June 27, 2019

**BOARD OF COUNTY COMMISSIONERS  
ORANGE COUNTY, FLORIDA  
IFB NO. Y19-767-TA/ ADDENDUM NO. 2**

**FORCE MAIN SOUTH AREA PACKAGE 2**

SCALE: 1" = 20' HORIZ.  
1" = 5' VERT.

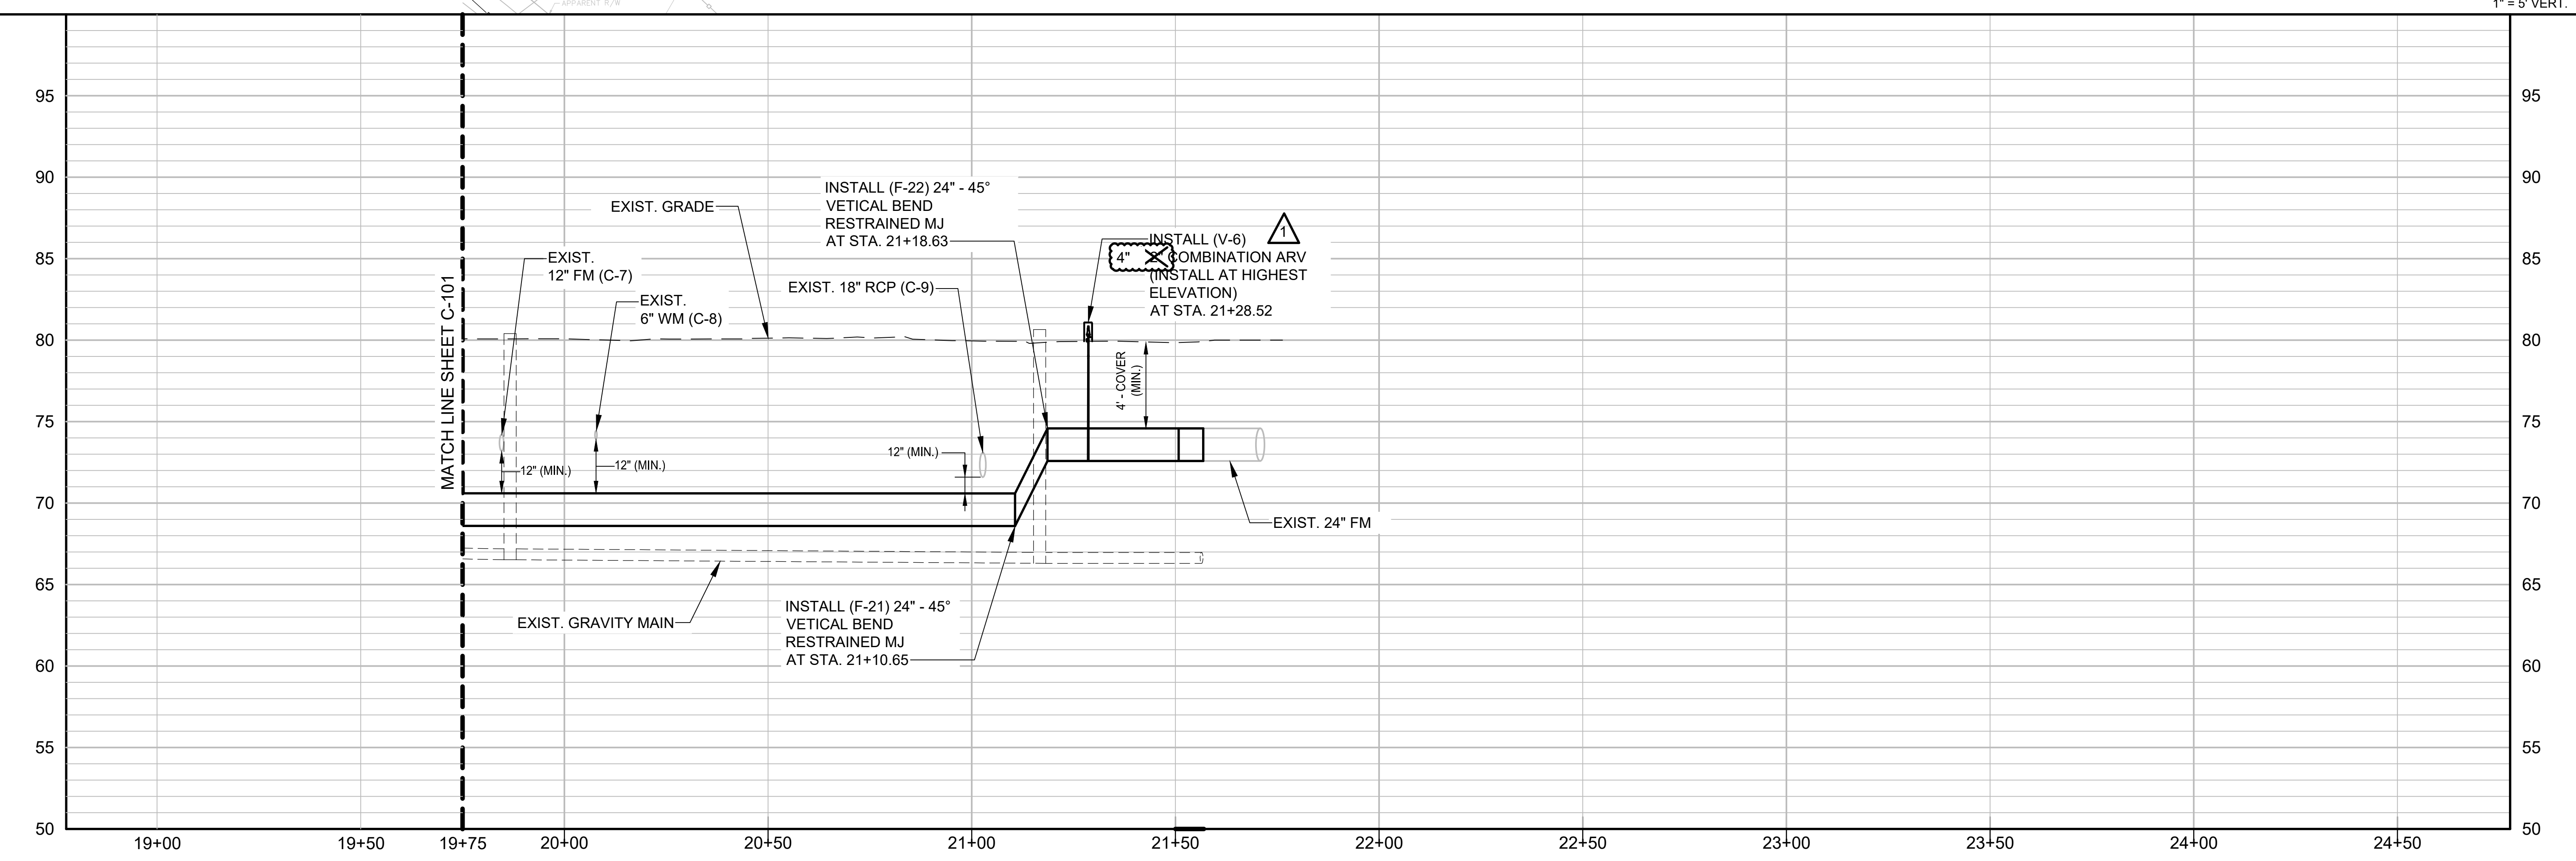
A: Bypass note has been deleted from sheets C100-C102 and C200-C201

- a. **Removal of Bypass note on sheets C-100, C-101, C-102, C-200 and C-201.**
- b. **Revision of ARV size on sheets C-100, C-101 and C-102.**
- c. **Revision of valve size V-13 on sheet X-100.**

SCALE: AS SHOWN  
 DRAWING NO.: **C-200**  
 SHEET: 12 OF 17

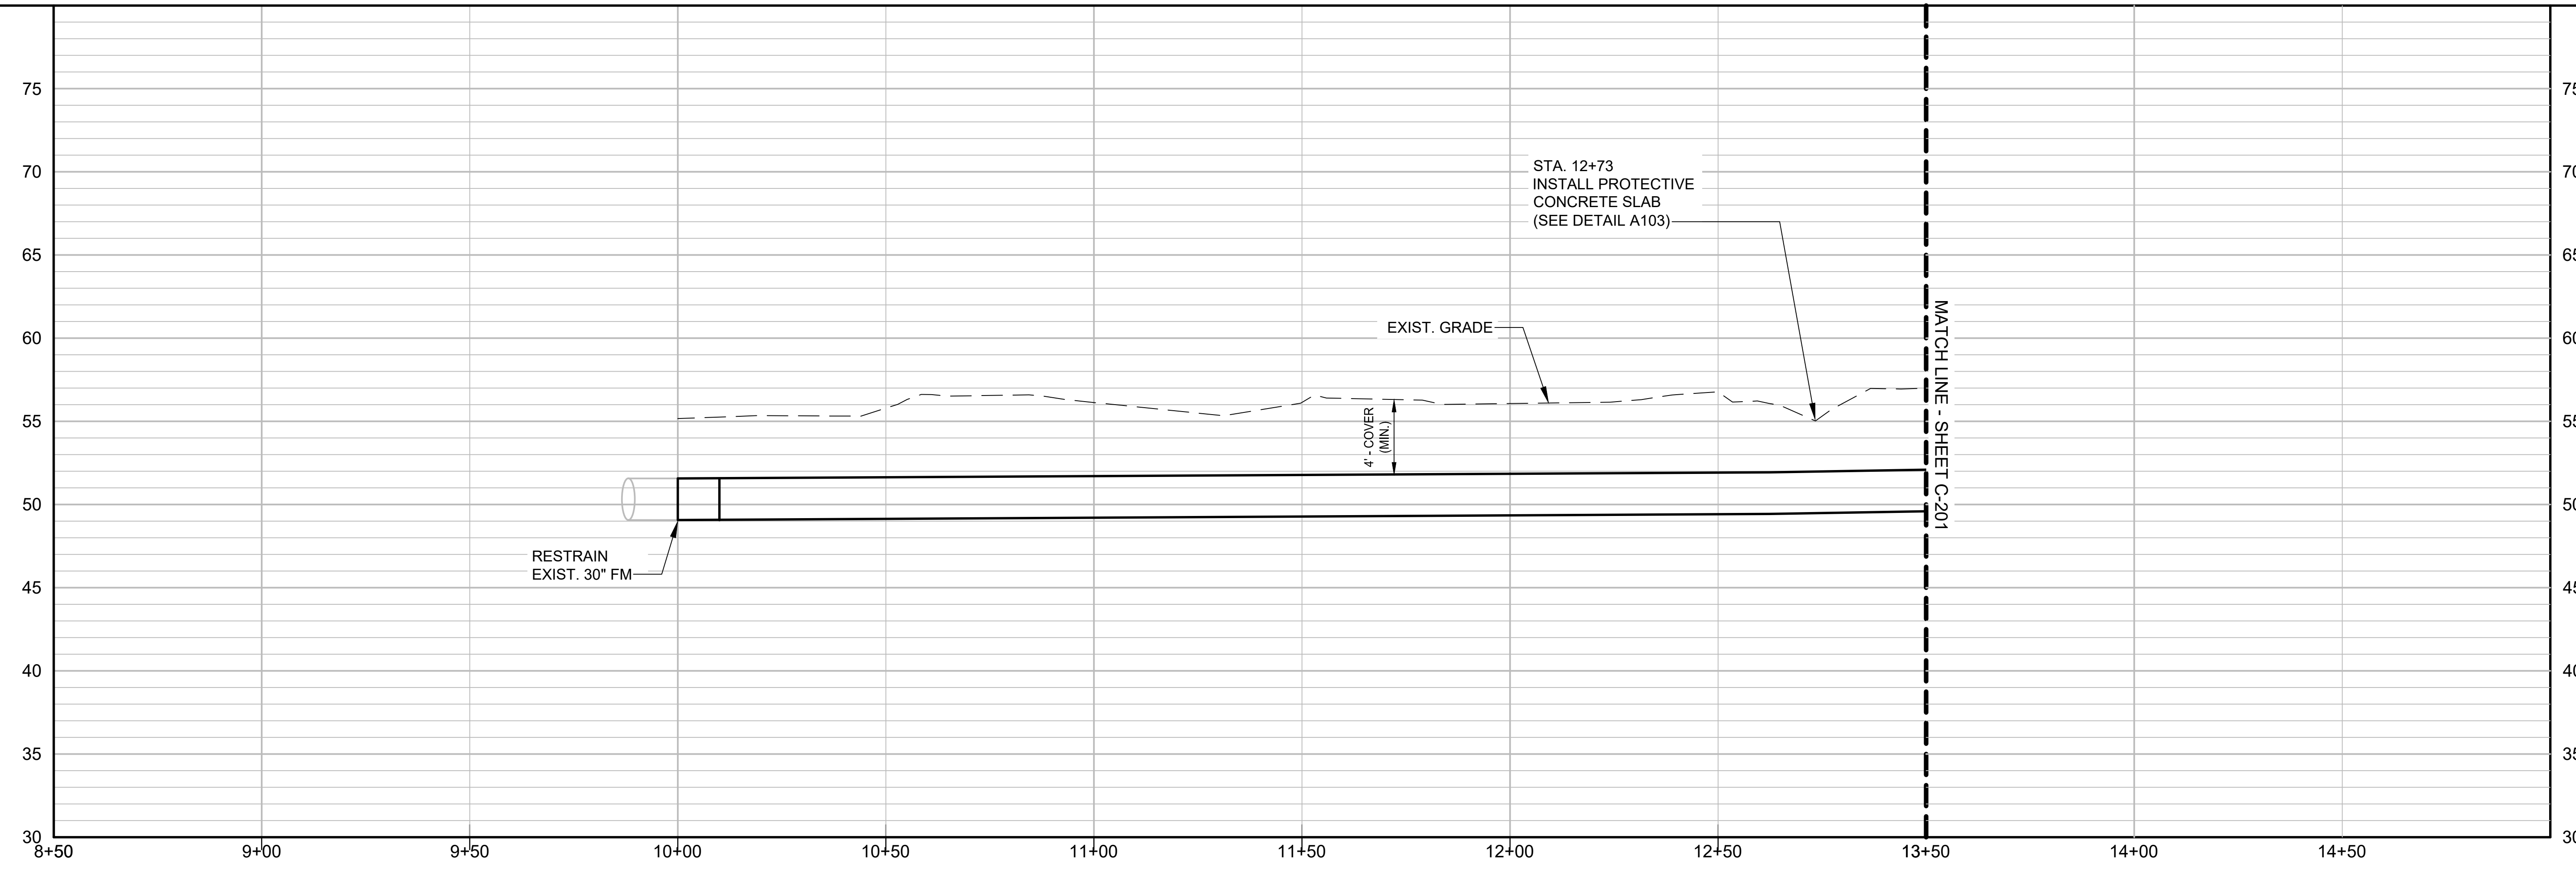
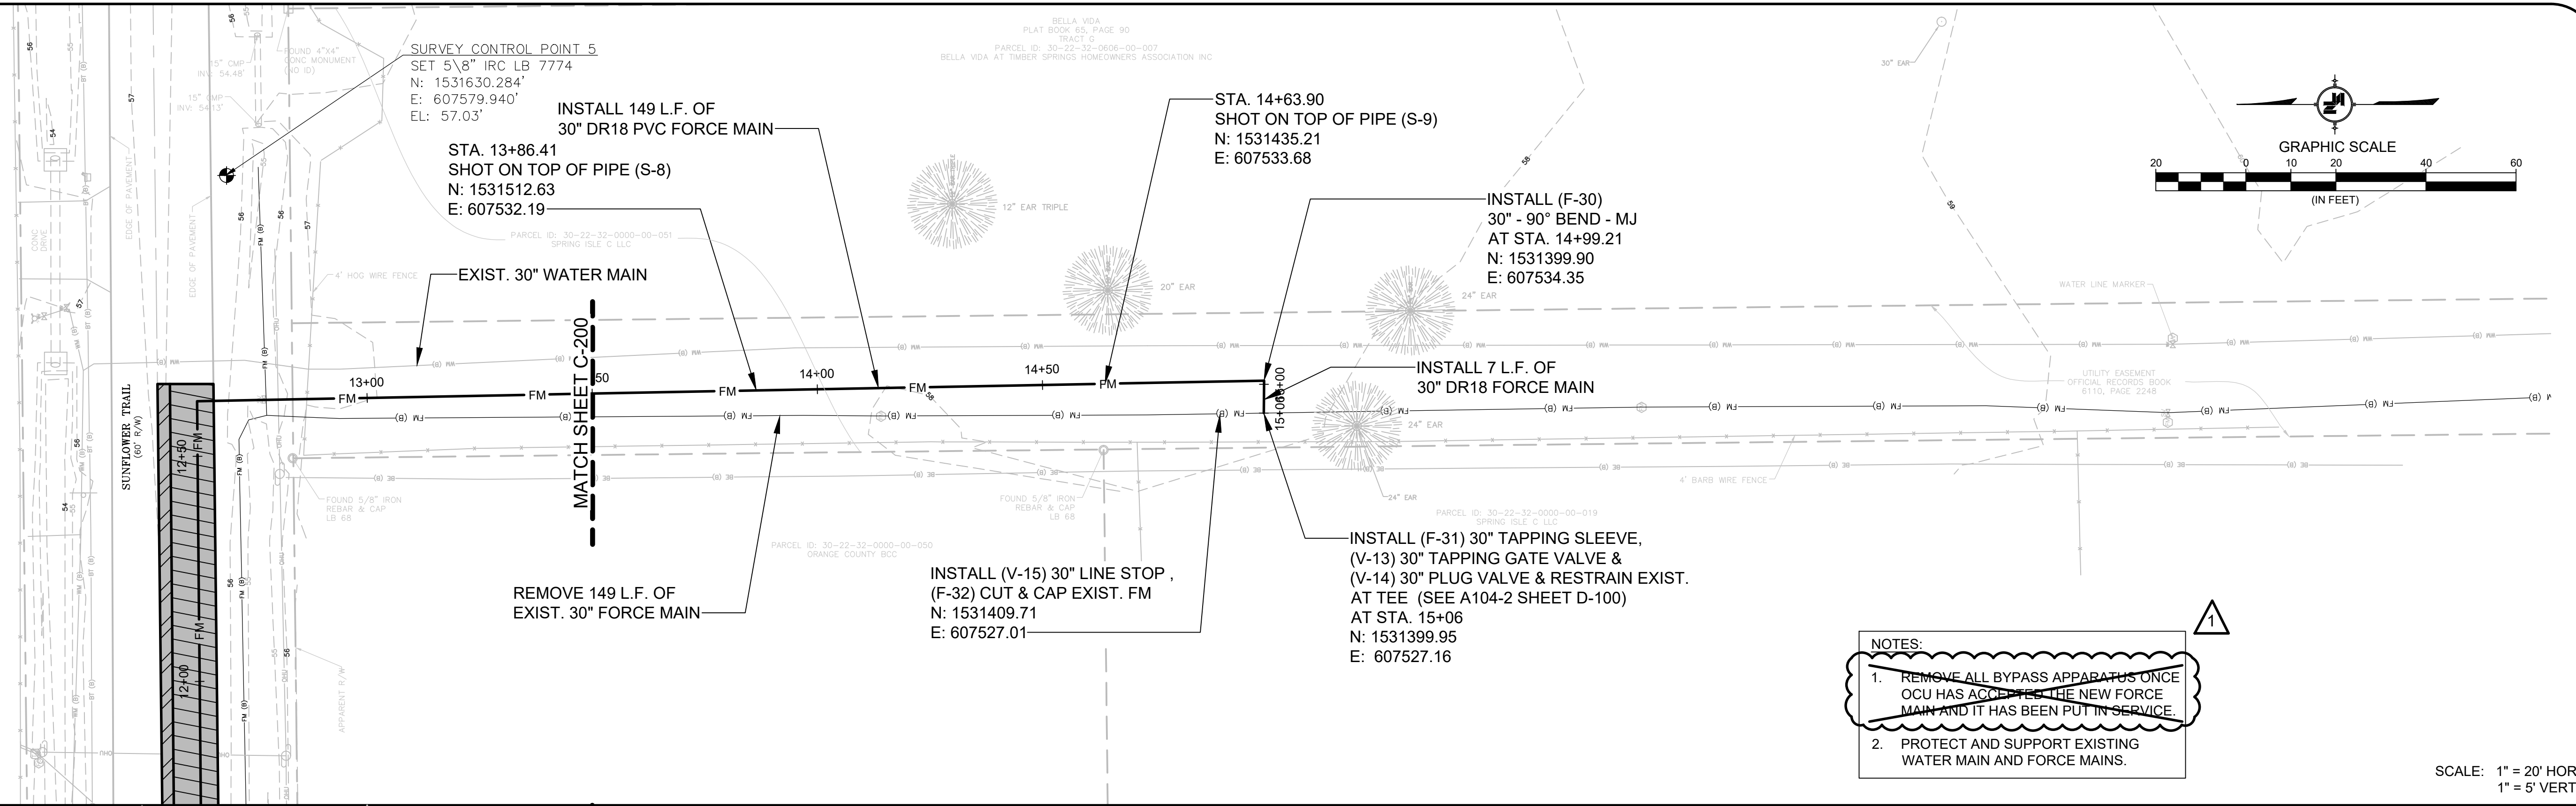
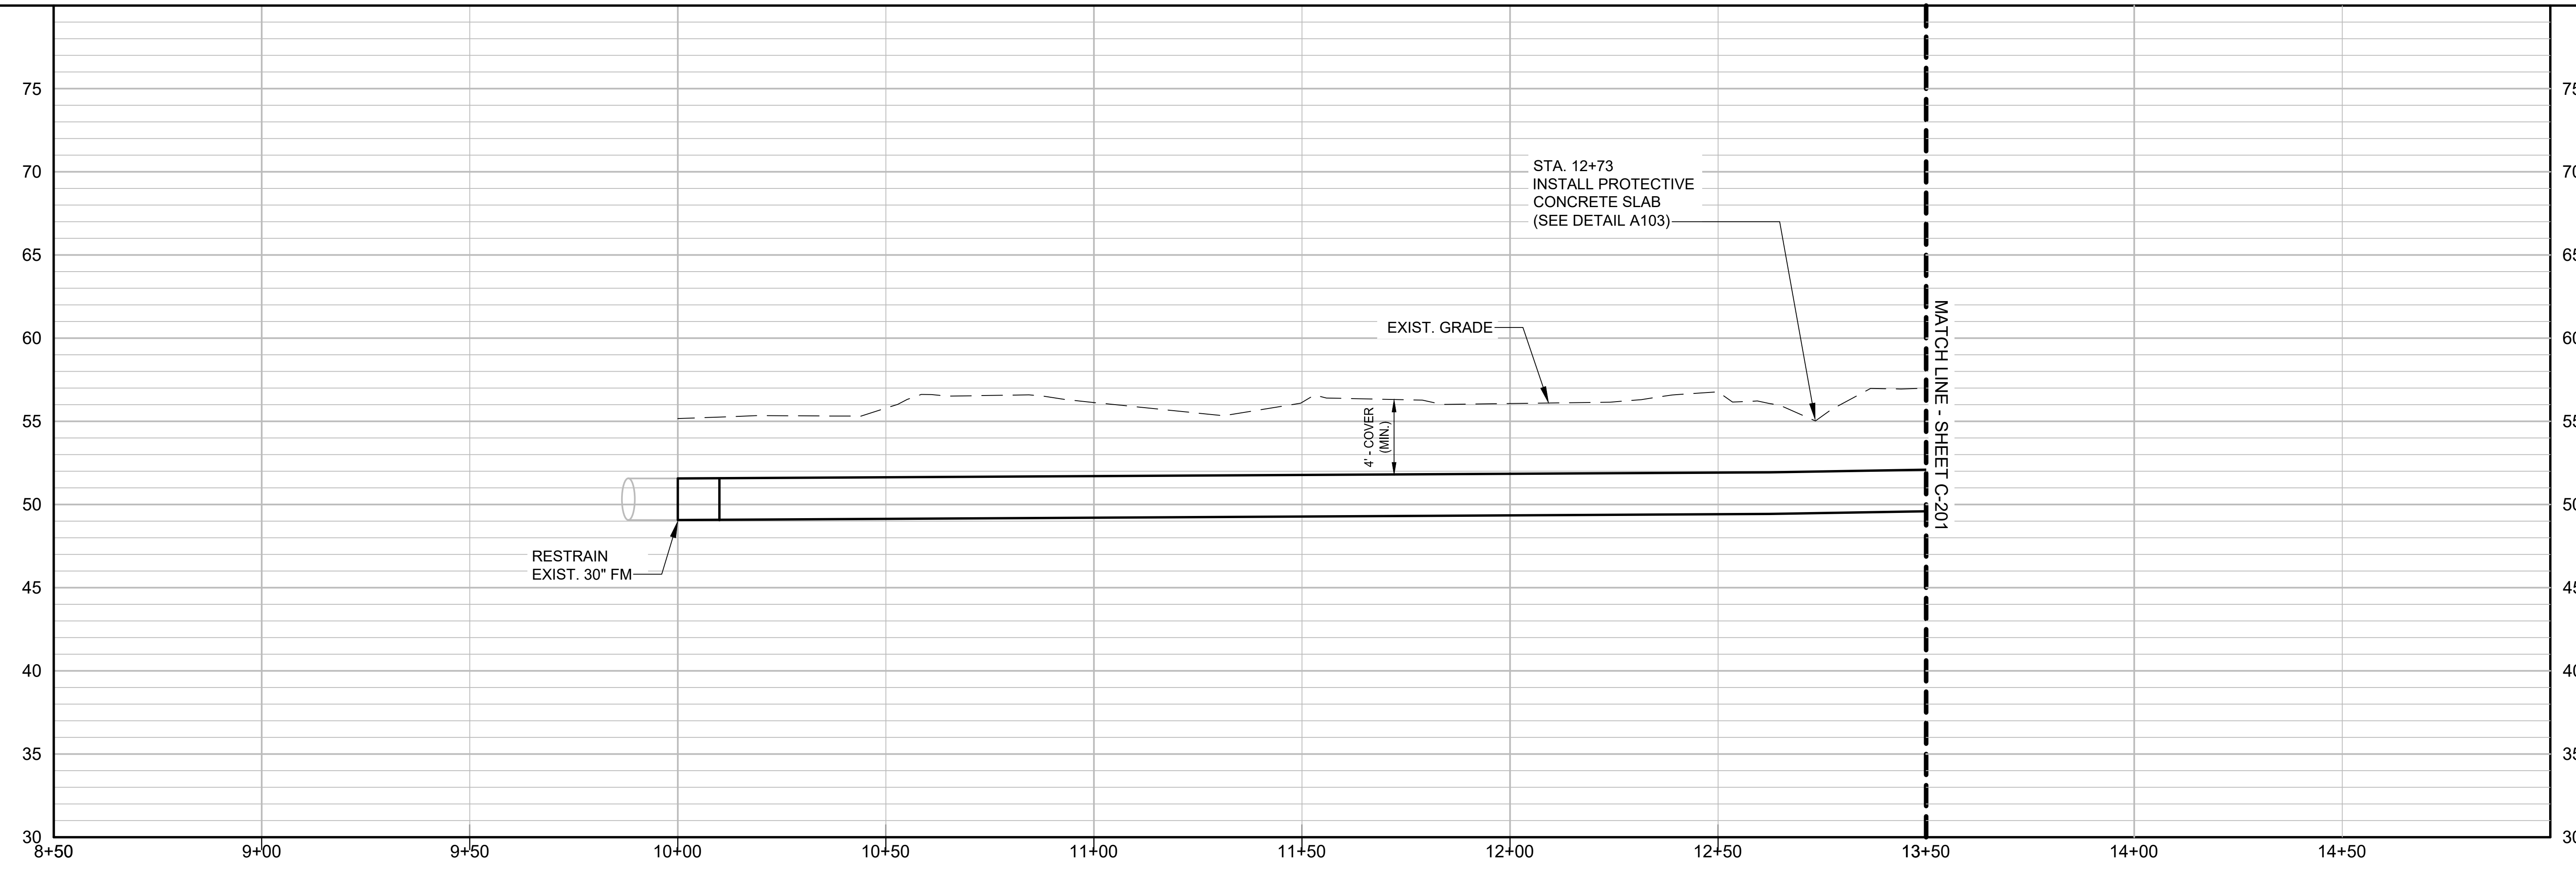
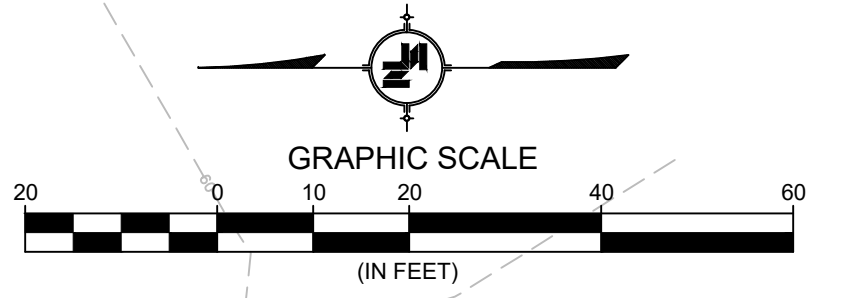
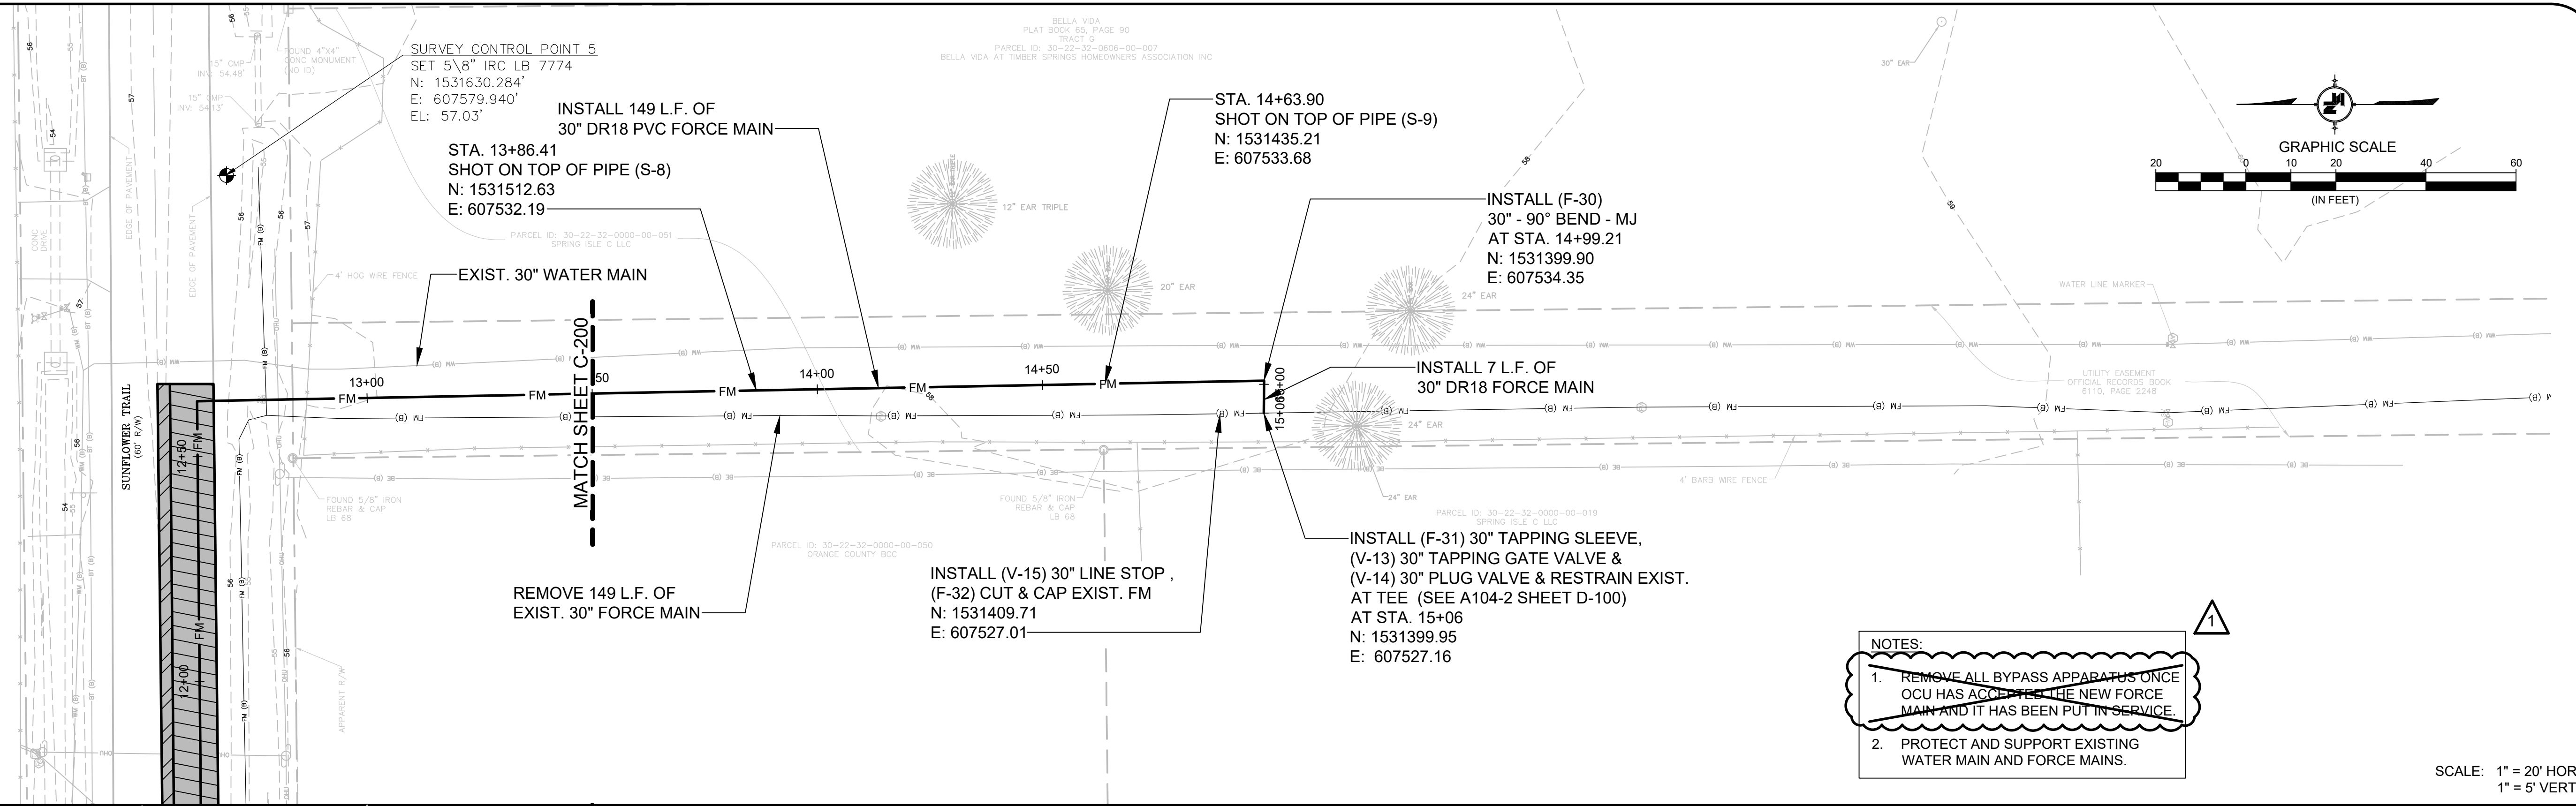
**4. Q: There is not a Bid Item for 6" Concrete Pavement Replacement. The driveway on Sunflower Trail on C-200 should be 6" per Figure A705 on D-102. Please provide bid item for 6" concrete pavement.**

**19. Q: Please add pay item for 8" PVC FM to be removed as shown on sheet C200.**

A: Refer to revised Bid Schedule that includes item no. 17 - Concrete Pavement Replacement (6" thick)

A: Pay item 21 has been revised to cover the removal of the 8-in PVC force main stub out.
